Memorandum

Subject: Pre-application: Z2025000110
Applicant Name: 8445 SW 94th Street Mixed-Use Building

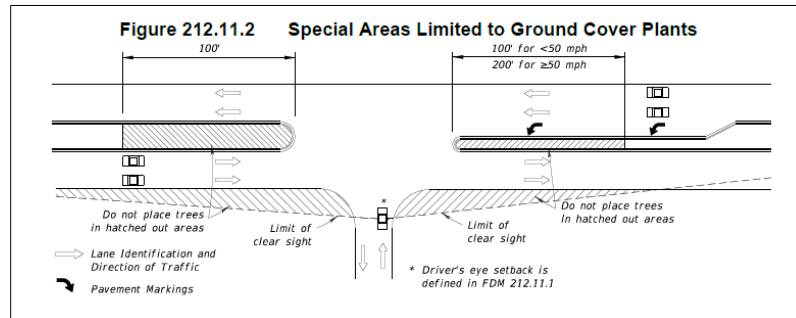
1. Exit driveways must comply with clear sight visibility requirements for both pedestrians and vehicular traffic. Provide clear sight visibility triangles on the site and landscape plans

to demonstrate compliance with these requirements. Please ensure to clearly illustrate both (pedestrian and vehicular) sight triangles following the MDC Traffic Operations Manual and FDOT Standards. Note that according to the latest FDOT FDM manual Section 212.11.6, trees may not be placed within the hatched-out areas of the sight triangles, as shown in the figure below.
